PROJECT:	CENTENNIAL PUBLIC SCHOOL ADDITION AND RENOVATION	PROJECT NO.	L13030
FROM:	BVH ARCHITECTS	DATE:	NOV. 18, 2013
TO:	CHEEVER CONSTRUCTION	ADDENDUM NO.	BID PACKAGE #5 ADDENDUM #1

CENTENNIAL PUBLIC SCHOOL ADDITION AND RENOVATION BP5 ADDENDUM 01 - EXHIBIT A

REF. SHT# C1.3

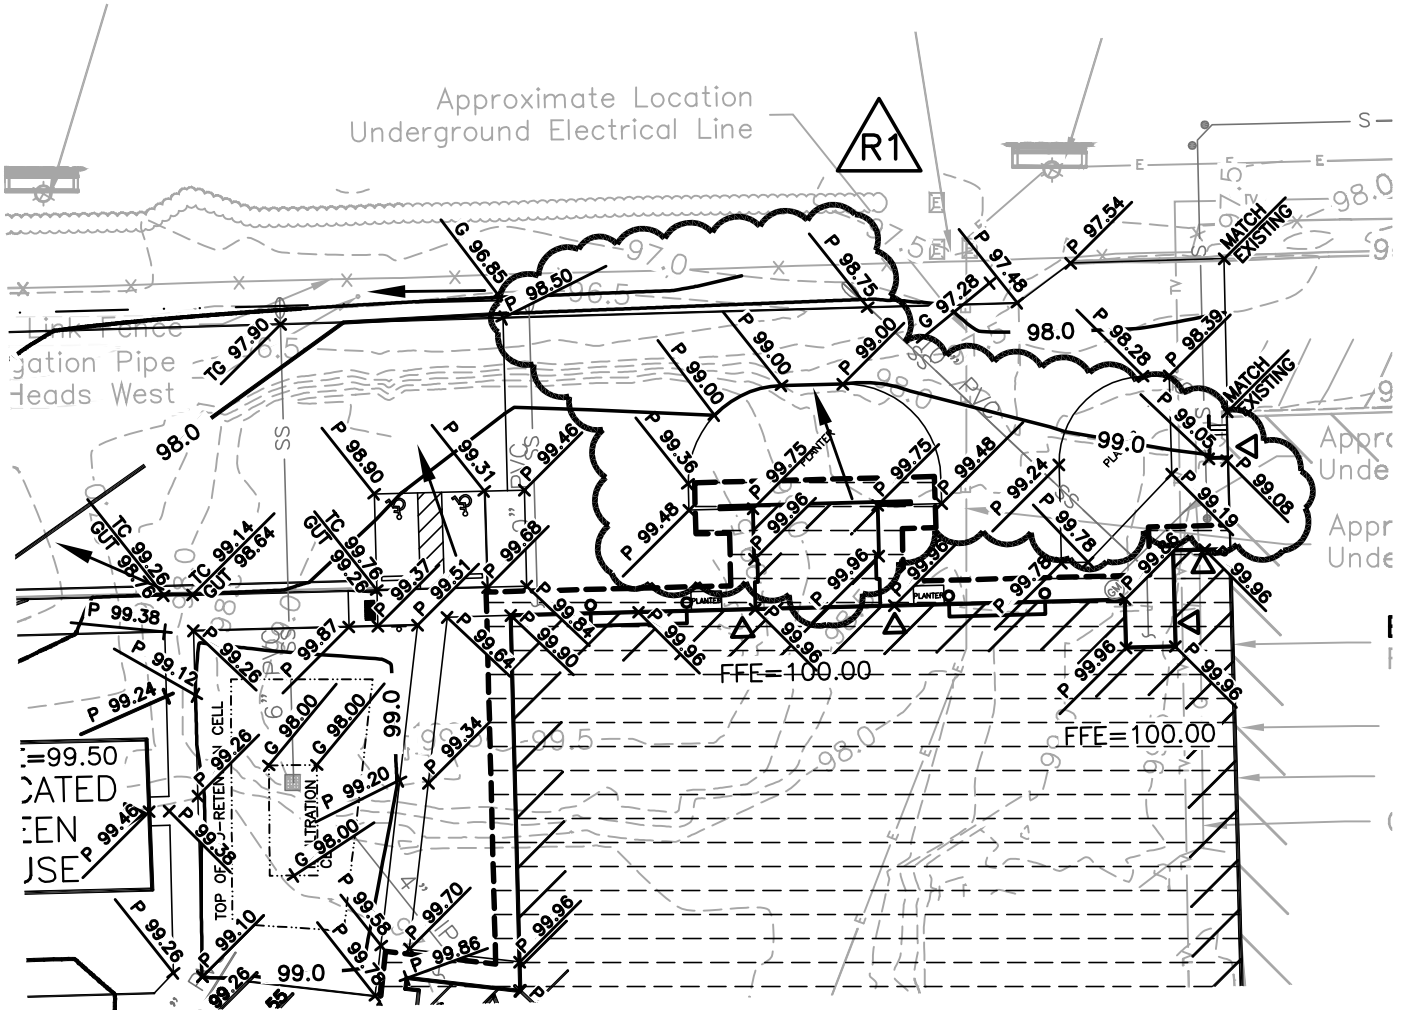
- A. Sheet C1.3, GRADING OVERVIEW PLAN. See attached 'Exhibit D'.
 - 1. Revised spot grades
 - 2. Delete Bio-retention Infiltration Cell Backfill Note 2 – 50% Topsoil less than 5% maximum clay content.

- 3. Add Bio-retention Infiltration Cell Backfill Note 2 – 50% Compost
 - 4. Add Bio-retention Infiltration Cell Backfill Note 5 – Infiltration Cell depth shall be 2.0 feet

ISSUED FOR:	DATE:	BY:
REVISED SPOT GRADES	11/18/13	NB

REF. SHT# C1.4

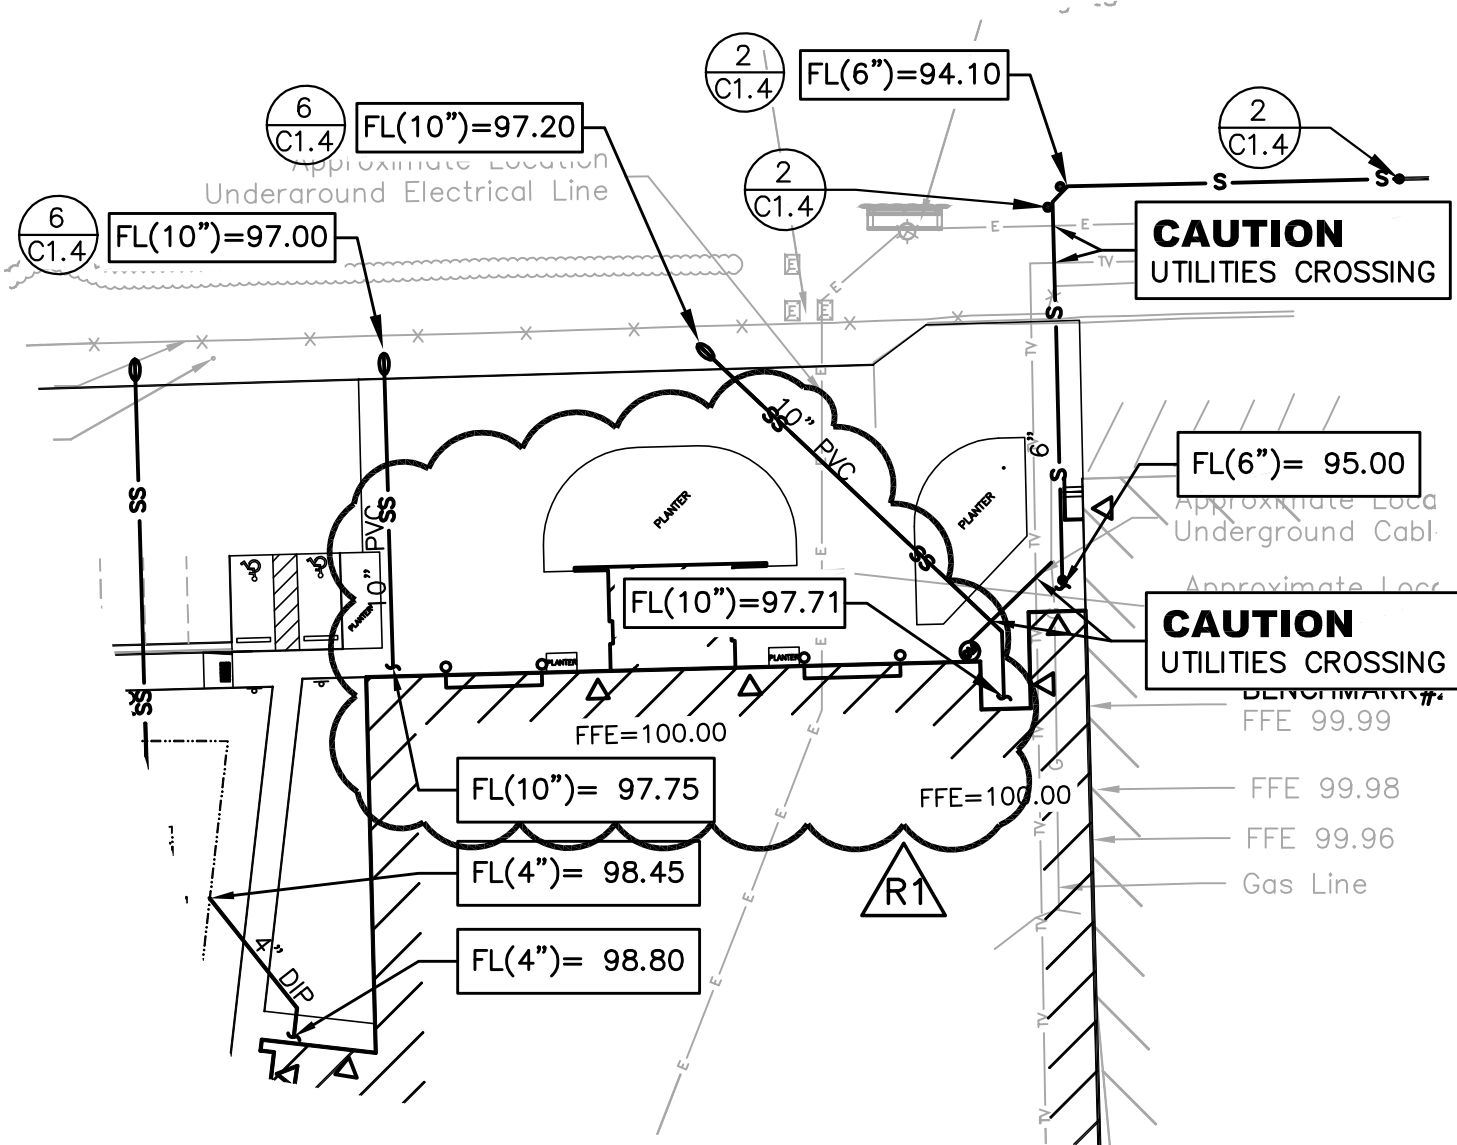
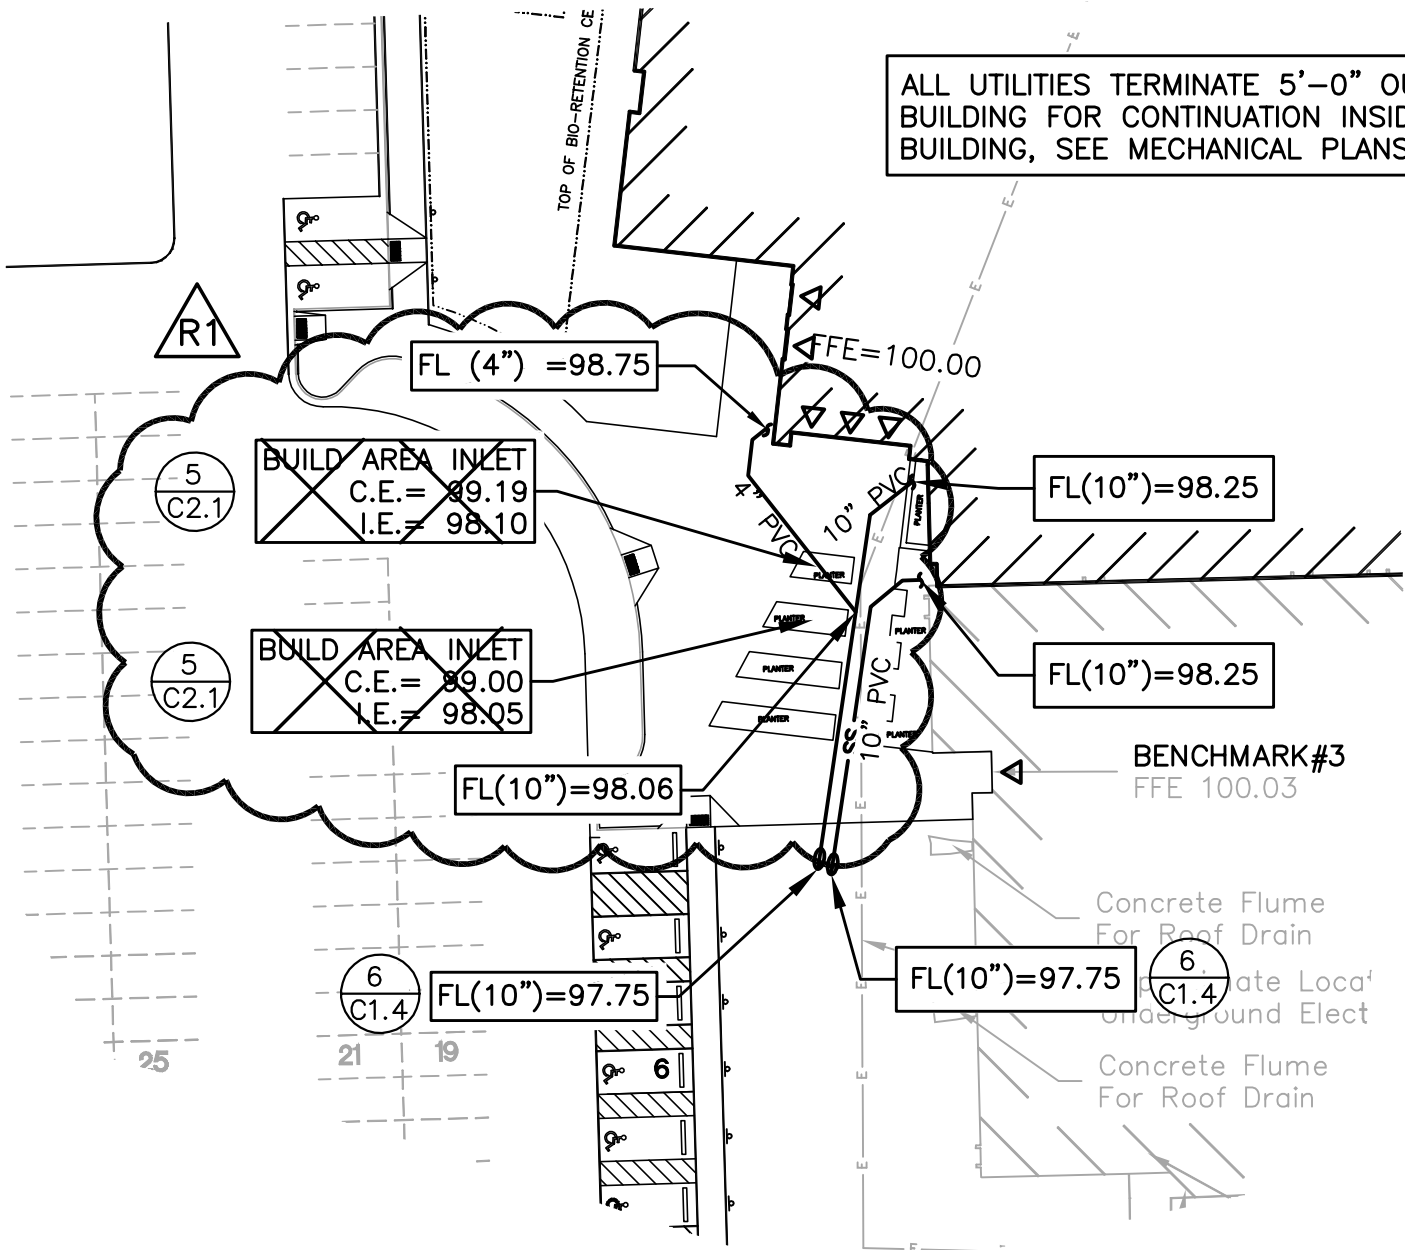
- B. Sheet C1.4, UTILITY PLAN. See the attached 'Exhibit D'.
 - 1. Revised pipe materials and flowlines
 - 2. Deleted inlets on south side of building
- C. Sheet C2.1, MISCELLANEOUS DETAILS. See the attached 'Exhibit D'.

ISSUED FOR:	DATE:	BY:
REVISED FLOWLINES, PIPE MATERIAL	11/18/13	NB

5
C2.1

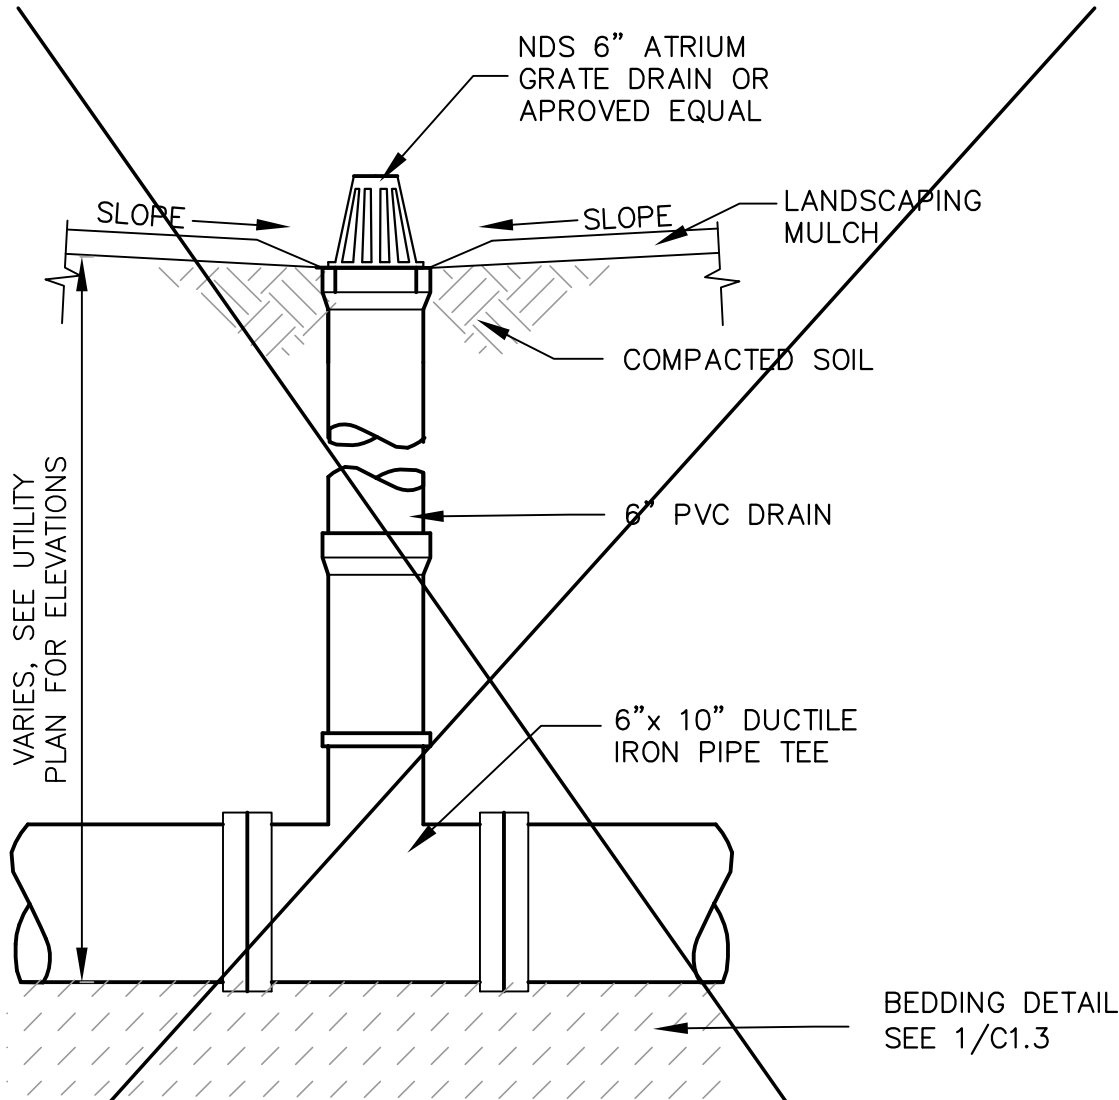
- 1. Deleted Detail 5
 - 2. Revised Detail 7
- D. Sheet A7.2, FRAME TYPES, Frame A17. See the attached 'Exhibit E'.
 - 1. Added horizontal mullion to reduce translucent panel size to less than the allowable 5'-0".

ISSUED FOR:	DATE:	BY:
DETAIL NOT USED	11/18/13	NB

7 CONCRETE STAIR DETAIL
 C2.1 NO SCALE

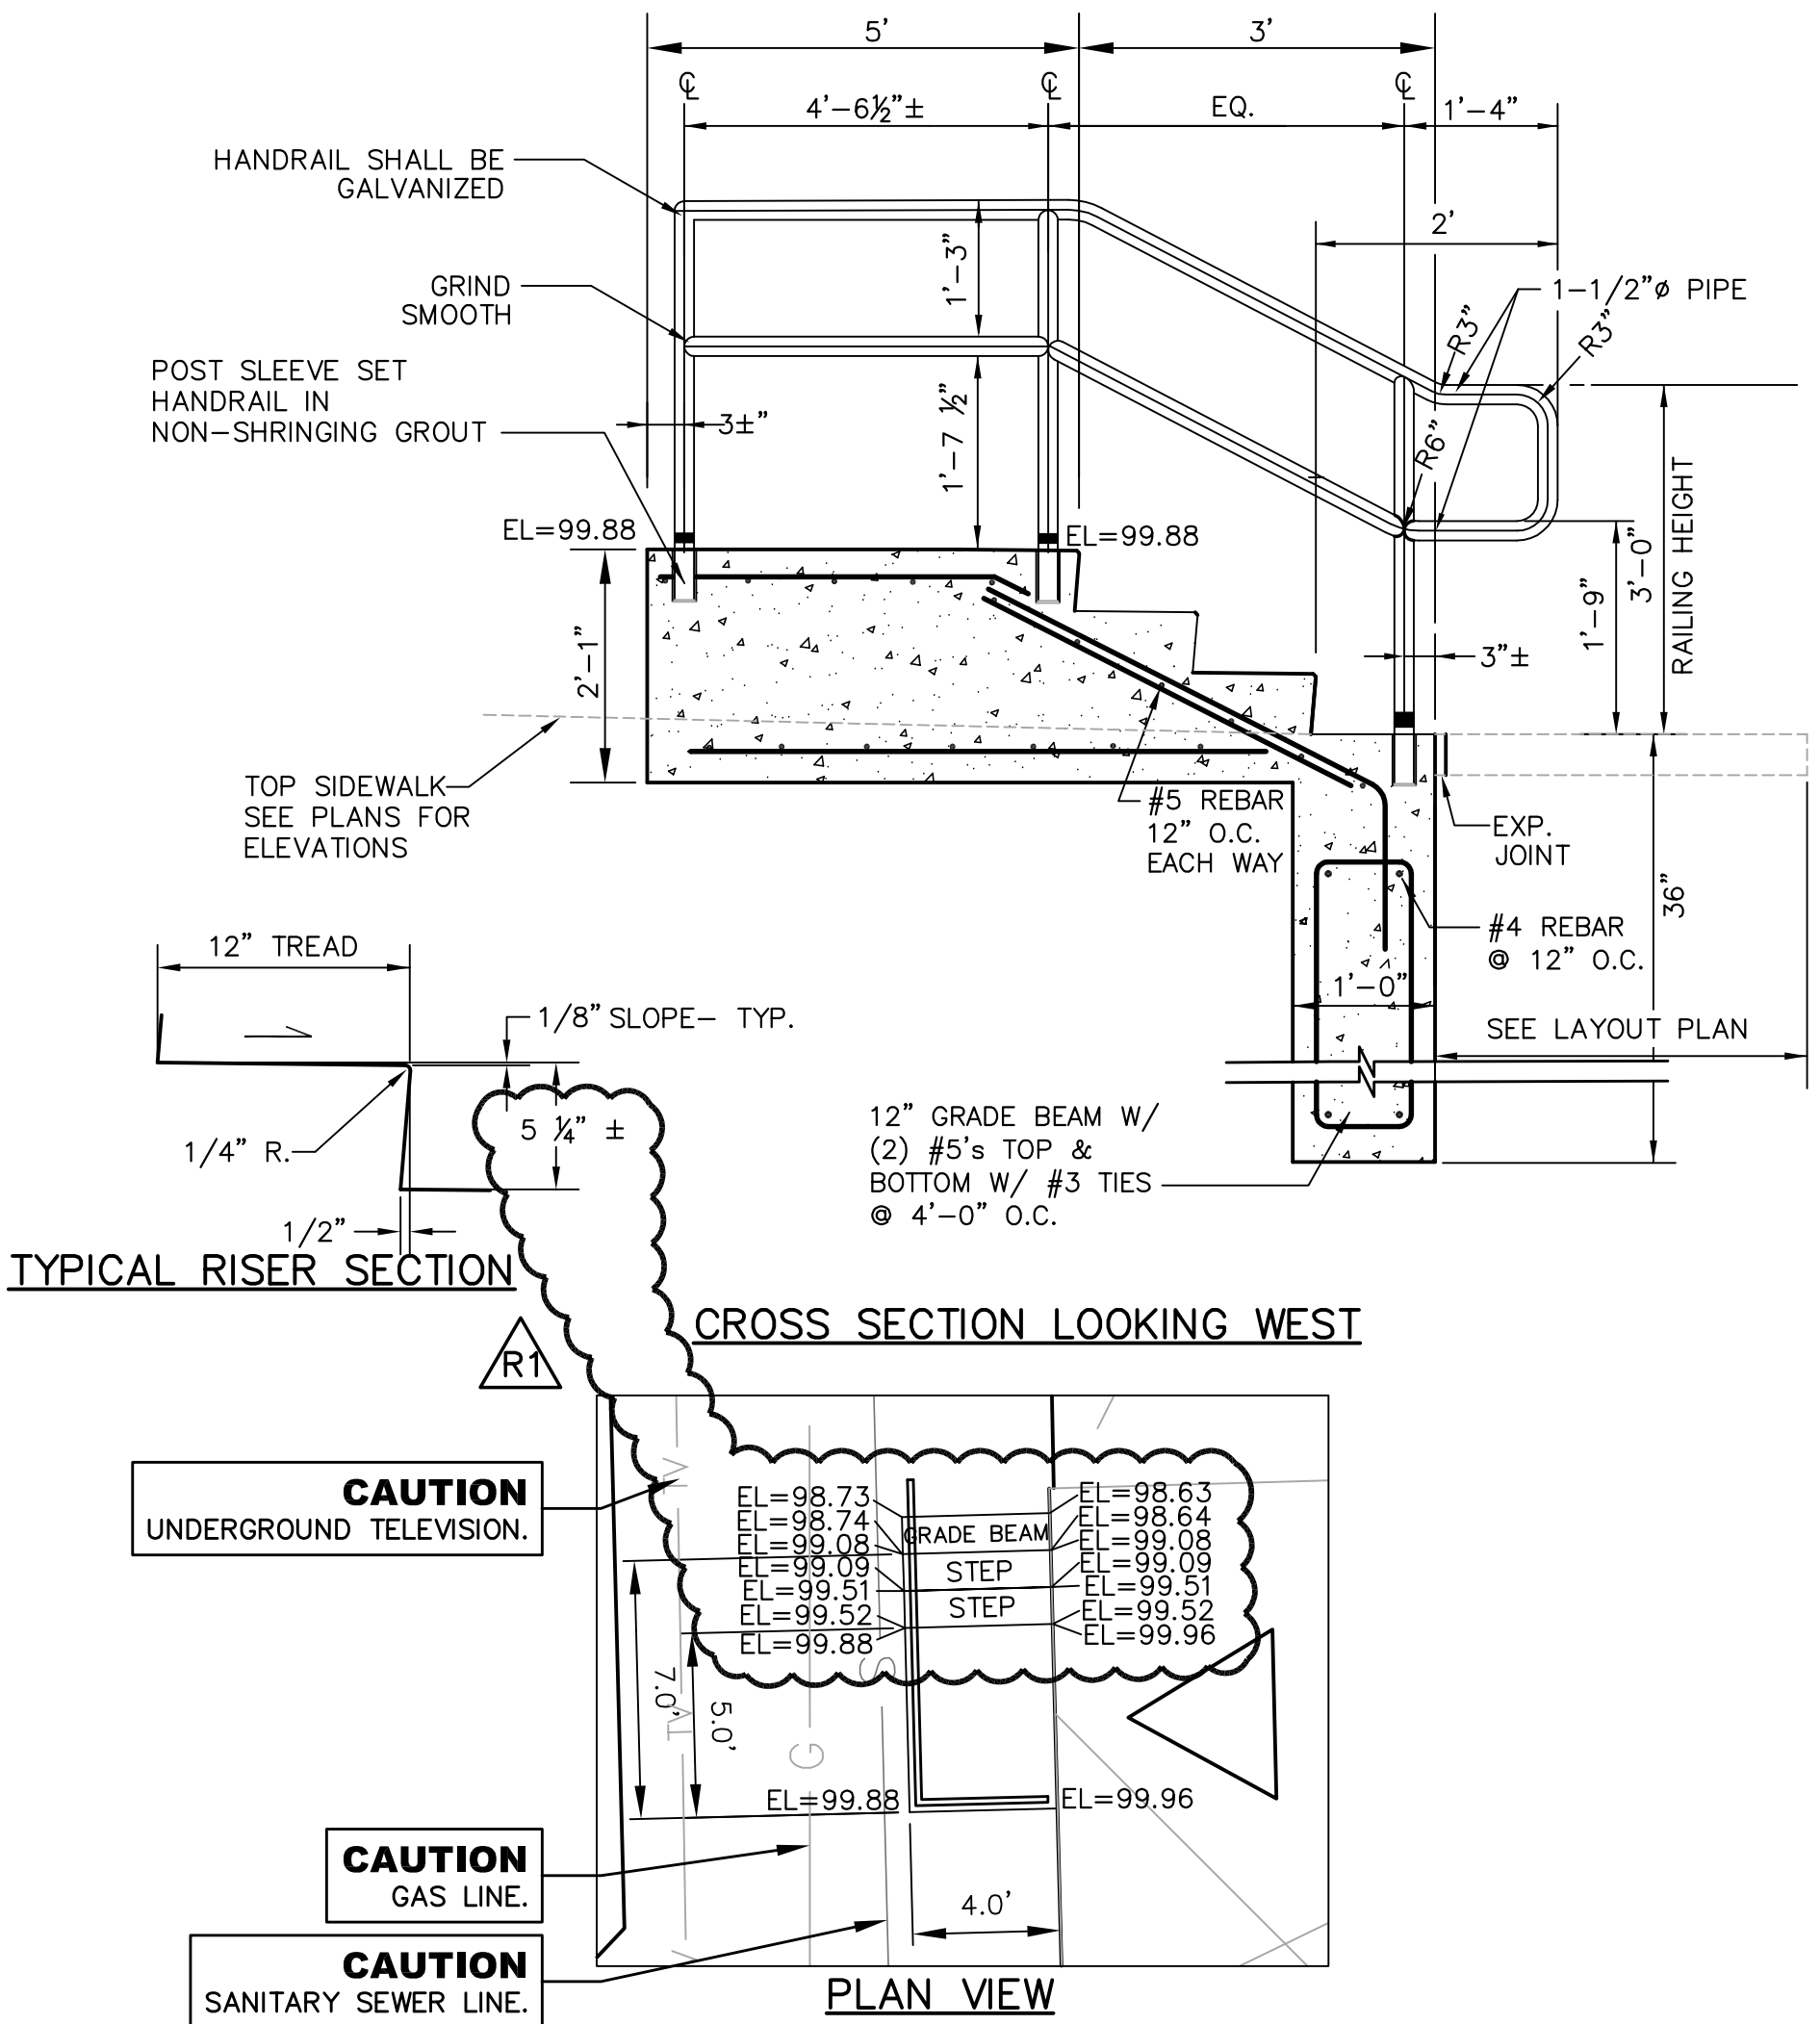
ISSUED FOR:	DATE:	BY:
REVISED ELEVATIONS	11/18/13	NB

2 ACCESSIBLE PLUMBING FIXTURE GUIDELINES

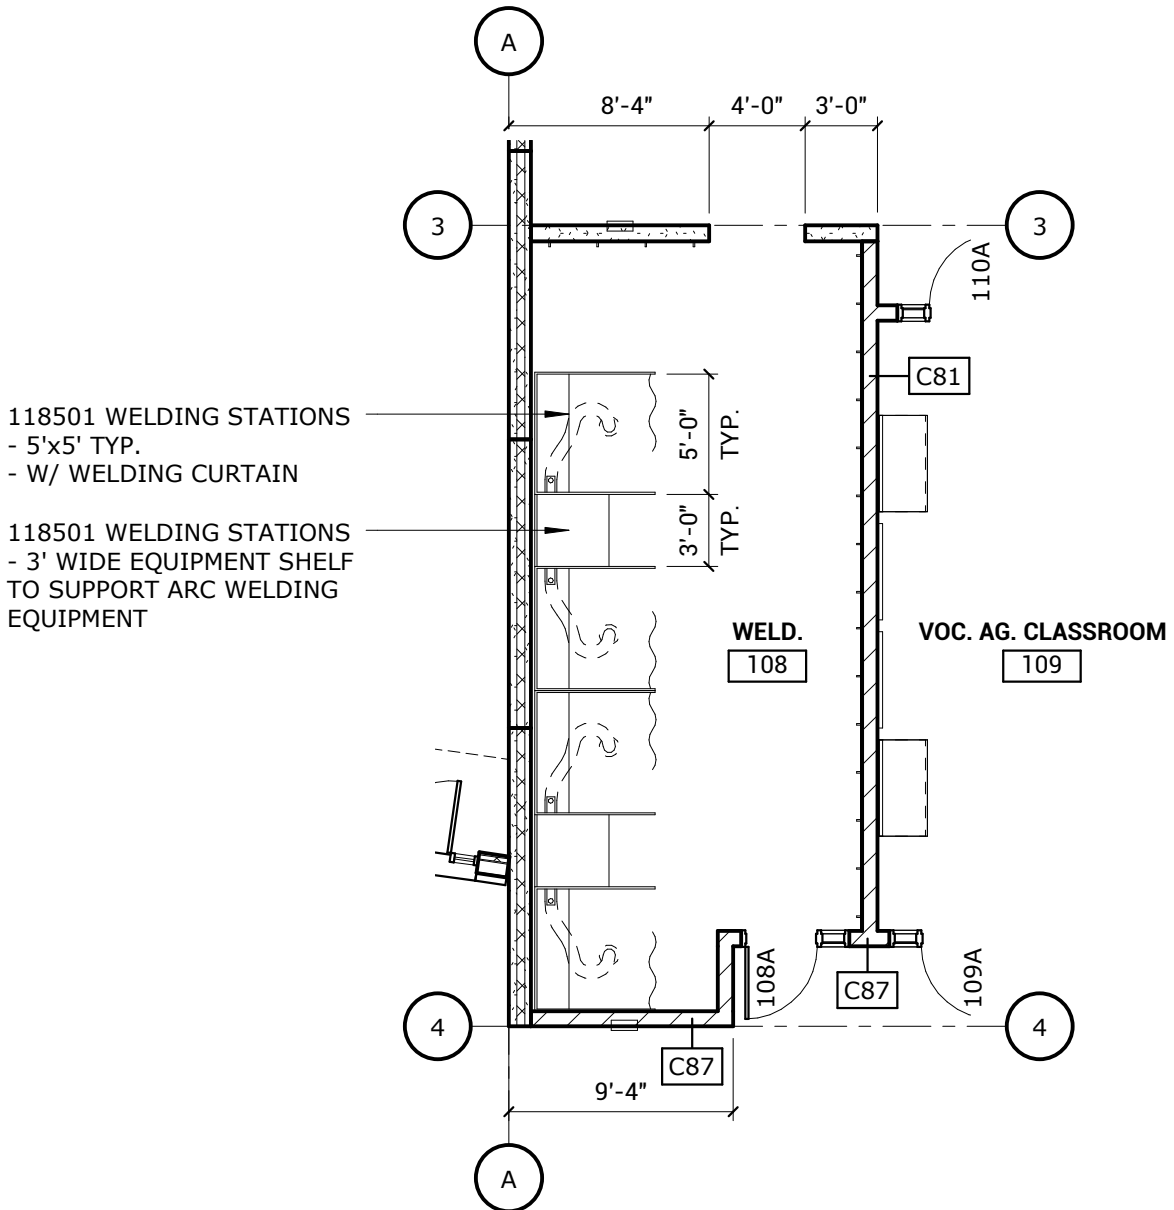
- E. Detail 2, ACCESSIBLE PLUMBING FIXTURE GUIDELINES. See the attached 'Exhibit E'.
 - 1. Added the Accessible Plumbing Fixture Guidelines containing typical fixture mounting height information.
